STEREO CONFIGURATION CHANGE REQUEST

For Office Use Only	TITLE: IMPACT EMC Configuration Waiver		CLASS:		NUMBER:					
				I	DATE:					
			II							
CONFIGURED ITEM: STS Number: Payload: STEREO Component : Experiment: IMPACT Component Part #: Serial #:			ORIGINATOR: Name: Dave Curtis Organization: U.C. Berkeley Phone: 510-642-5998 Email: dwc@ssl.berkeley.edu			PRIORITY: <input checked="" type="checkbox"/> Routine <input type="checkbox"/> Urgent <input type="checkbox"/> Emergency				
TYPE OF REQUEST:		RESPONSIBLE ORGANIZATION/INDIVIDUAL:			IMPACTS: (If yes attach additional pages)					
	Configuration									
	Deviation	#				COST:		Yes	<input checked="" type="checkbox"/>	No
<input checked="" type="checkbox"/>	Waiver	#				SCHEDULE:		Yes	<input checked="" type="checkbox"/>	No
	Other:									
REASONS FOR CHANGE:					RETEST REQUIRED:					
	Improvement		Test/Payload Failure		New Document:					
	Reliability	<input checked="" type="checkbox"/>	Specification Requirements		Other:

SIT INSTRUMENT ASSEMBLY

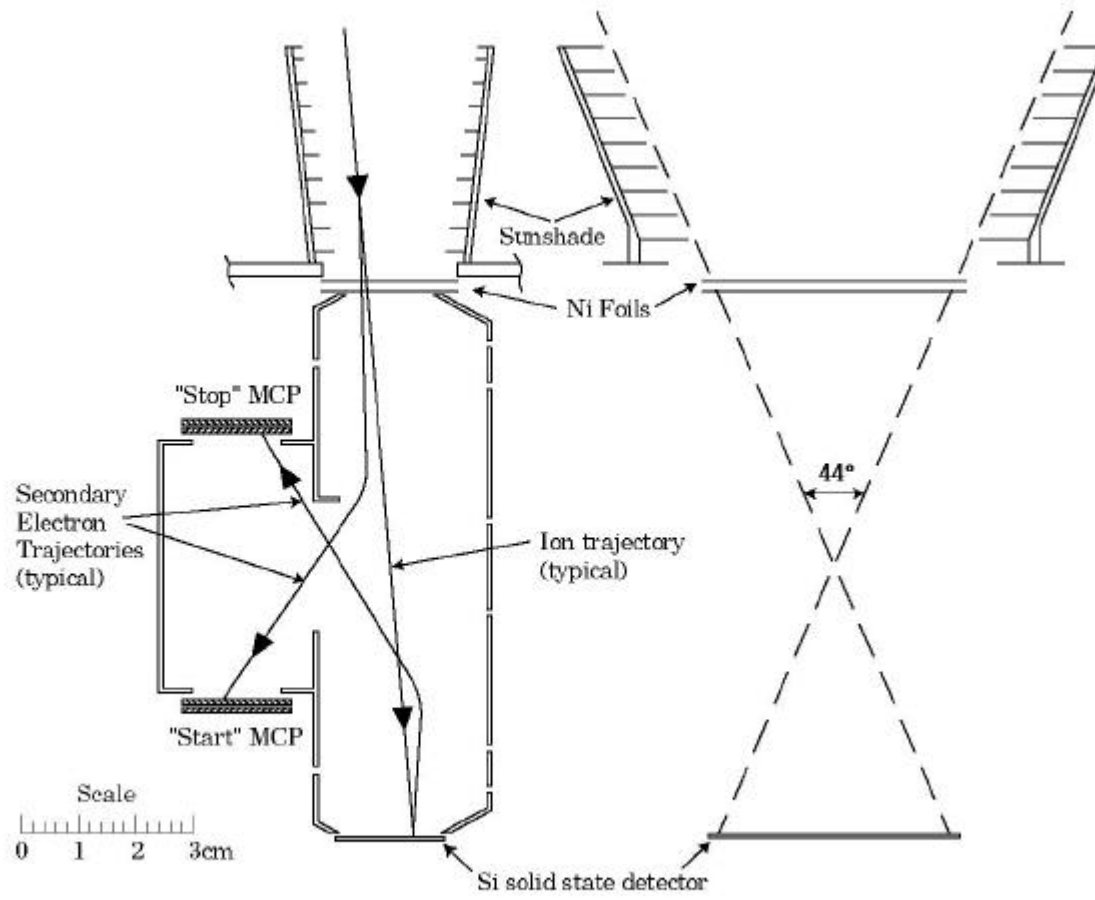
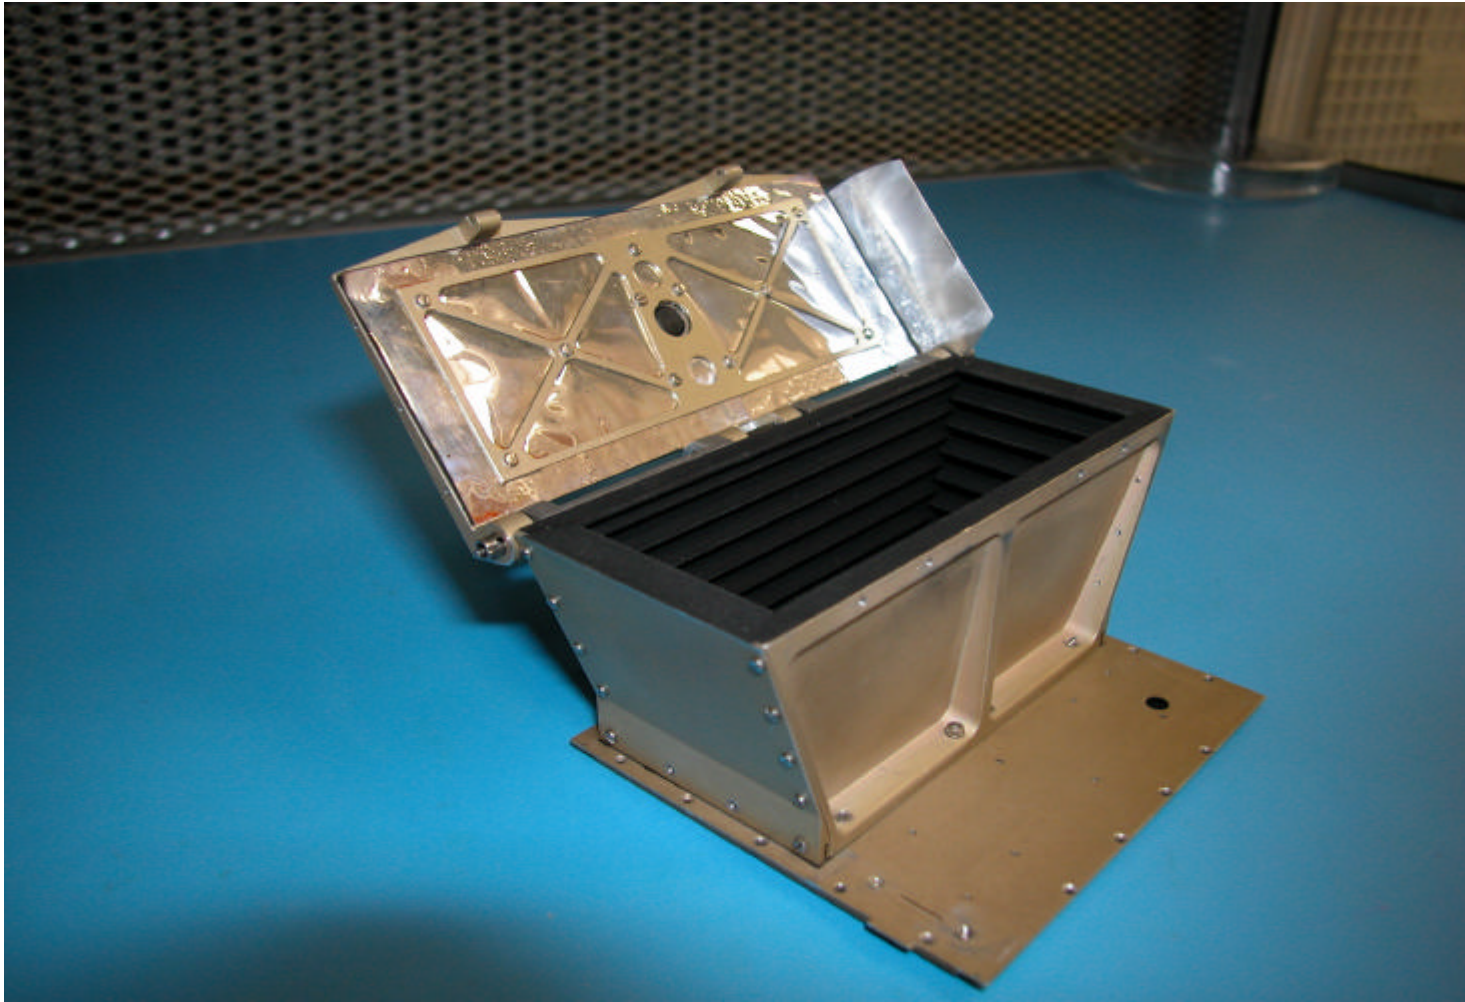
Collimator/Acoustic door: not installed

Collimator/Acoustic door is an aluminum protrusion on the front aperture of the SIT telescope. It provides acoustic protection to the very fragile SIT Nickel foils. It is completely outside the SIT Telescope and provides no shielding for EMC purposes. The nickel foil closes out the shielding on the telescope aperture and the Collimator/Acoustic cover bolts to the outside. Conductive tape will cover the holes and should provide the same characteristics as having it in place. Even if the door were available it is required that doors be open for radiated tests per the EMC requirements.

Pin puller Actuator: not installed

The pin-puller is mounted under the door and it's electrical connection is to the spacecraft harness. It is independant of the telescope EMC characterization. The pin puller and its harnessing is entirely outside the box (separately shielded).

Main SEP Assembly

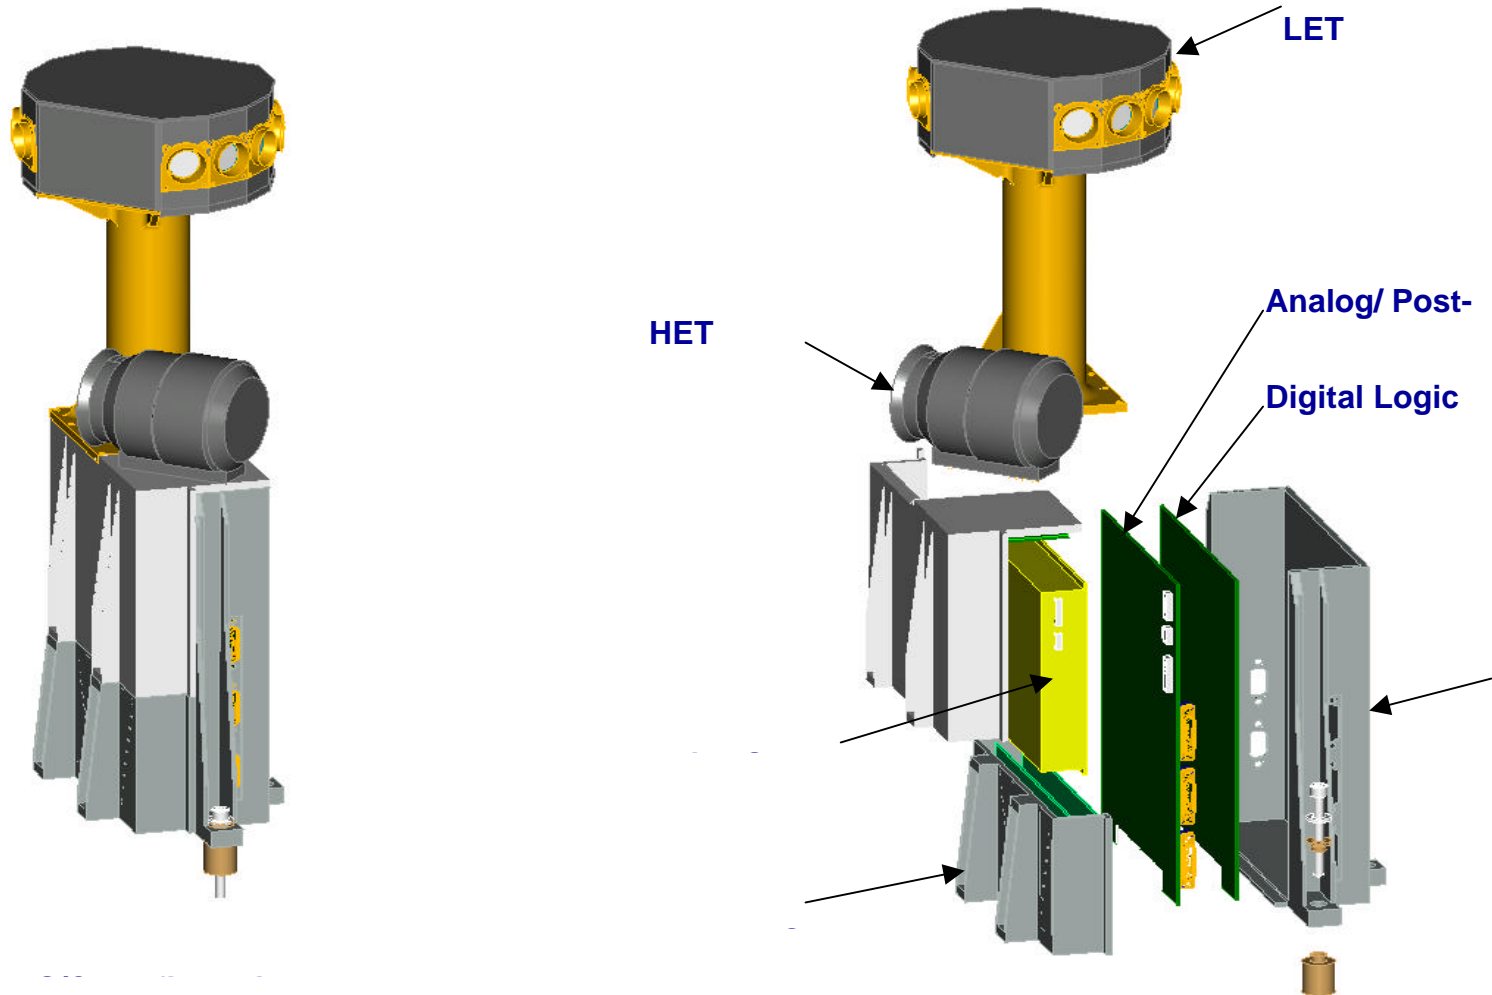
Purge Manifold: not installed

Purge manifold is an aluminum box mounted inside the Main instrument box. It takes incoming purge through an aluminum swagelock fitting and distributes it to the telescopes. It has no electrical connections. Conductive tape covering the screw holes will provide the same characteristics as having it in place. Electronics box will have to be opened to install, but only mechanical connections (screws) will be removed, nothing electrical.

LET Telescop Bracket

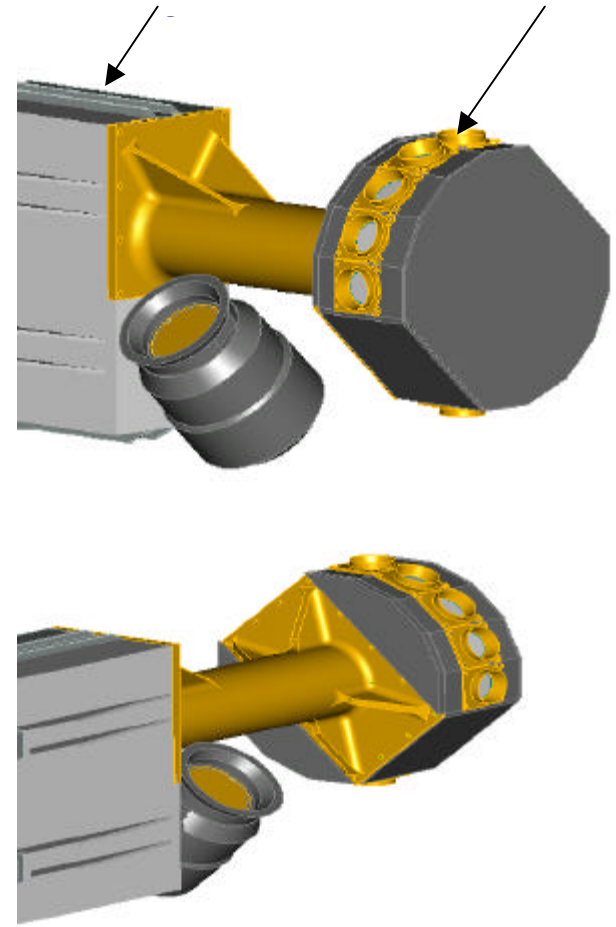
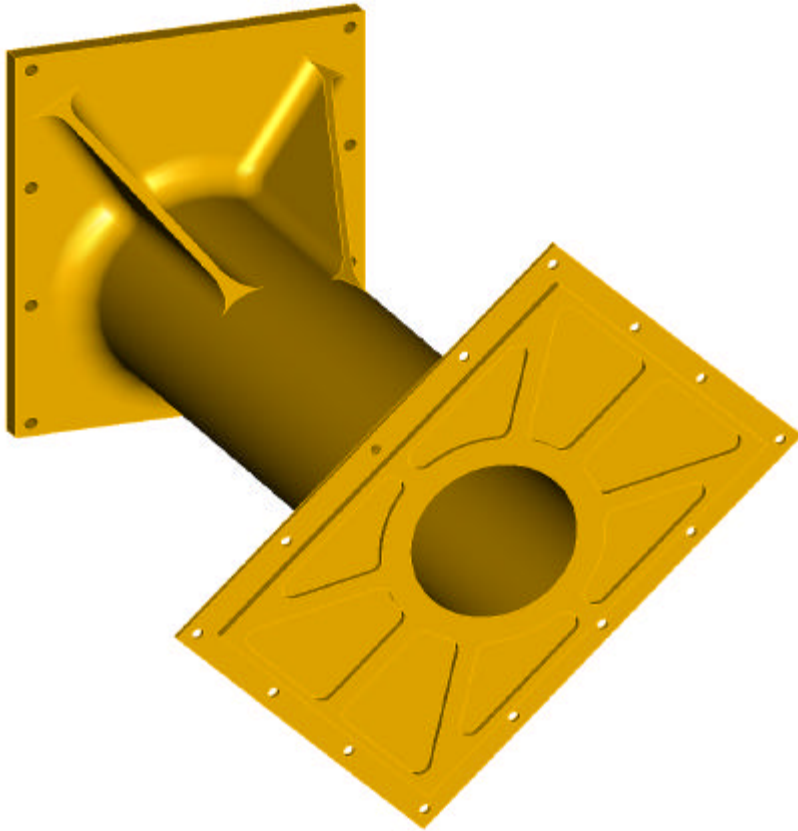
Telescope Mounting Bracket: Failed flight brackets without proper ribbing installed

Too much material was removed to give proper mechanical strength during final

machining. Existing brackets will be installed and swapped out prior to vibration. One electrical connection will be demated and mated to swap in flight bracket, but this connection is completely inside the instrument and should not be a factor for EMC.

Low Energy Telescope (LET) Schematic

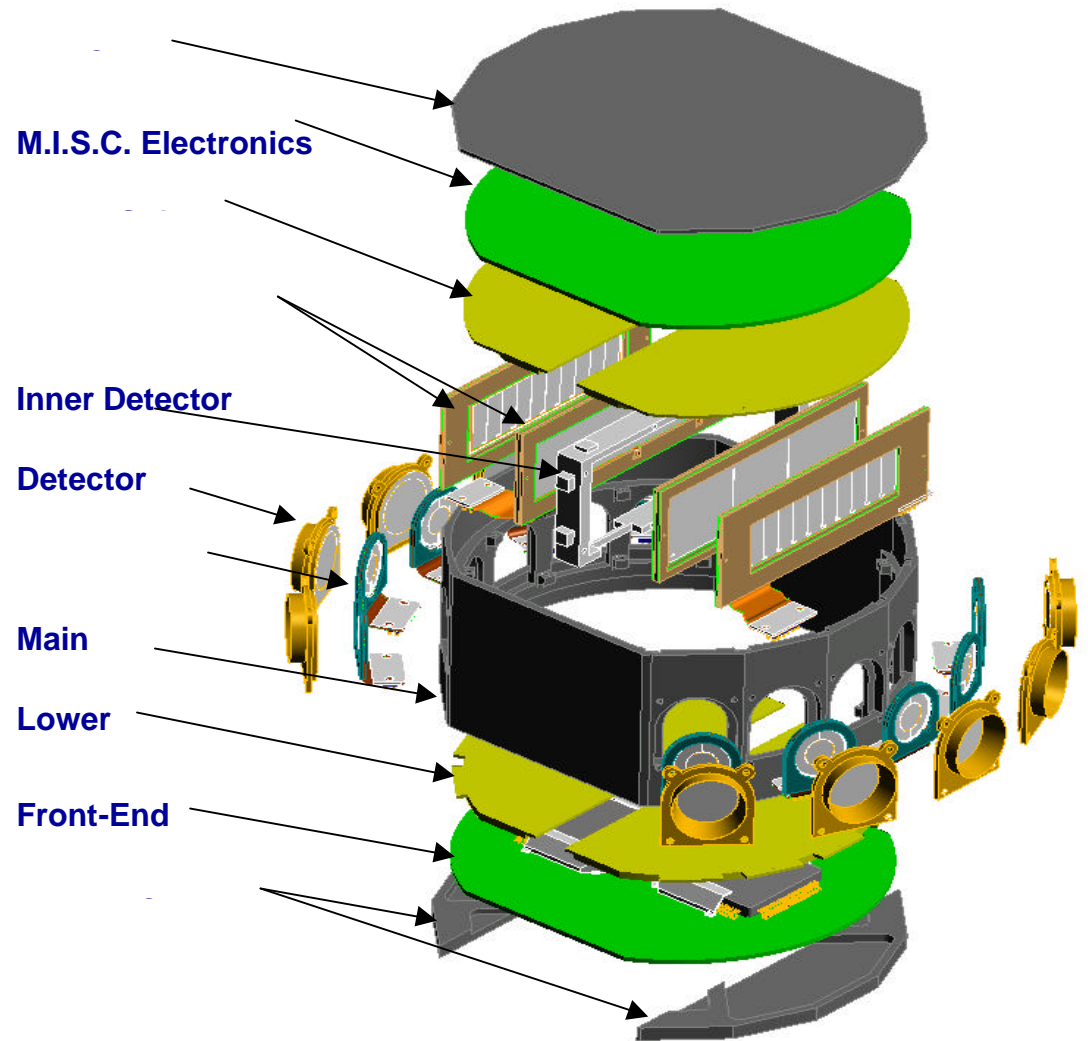
Detector Aperture Windows: non-flight windows installed

Front windows for LET Telescope are 1/3 mil Kapton film coated with a special Goddard Composite coating. They are mounted on the outside of the telescope in front of the L1 detectors. These are the same as the flight windows except they do not have ITO coating on them. NOTE: Some of these windows do not get ITO for flight. The windows are coated with VDA (same as flight) on the inside thereby closing out the electrical shielding of the telescope.

Secondary Collimators: not installed

Front apertures have a secondary collimator in front of the aperture window containing a second 1/3 mil Kapton foil. These collimators and windows attach outside of the shielded telescope.

HET Telescope Schematic and Assembly

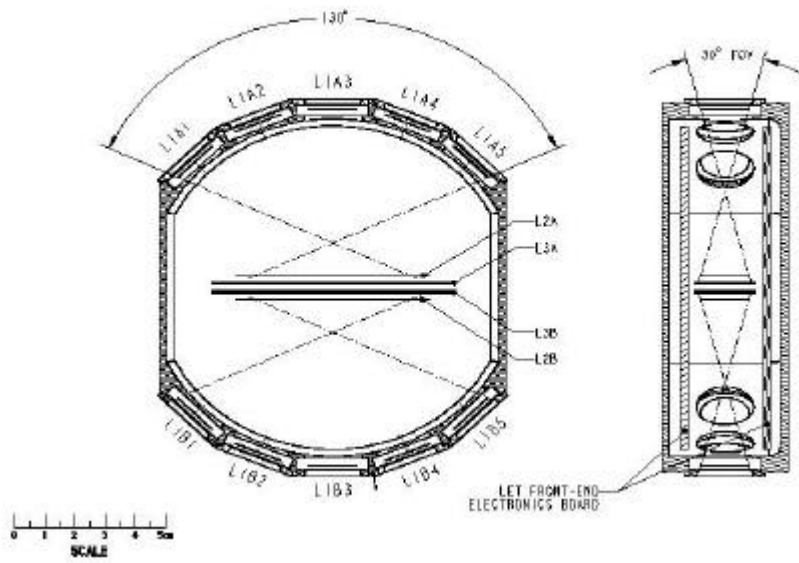
Detector Aperture Window: non-flight window installed

Front windows for HET Telescope are Kapton film coated with a special Goddard Composite coating. They are mounted on the collimator in front of the detector aperture. These are the same as the flight window except in thickness (non-flight 1/3 mil; flight 5 mil) and non-flight foils have no ITO coating on them. The windows are coated with VDA (same as flight) on the inside thereby closing out the electrical shielding of the telescope. No electrical connections will be breached in the replacement of these apertures.
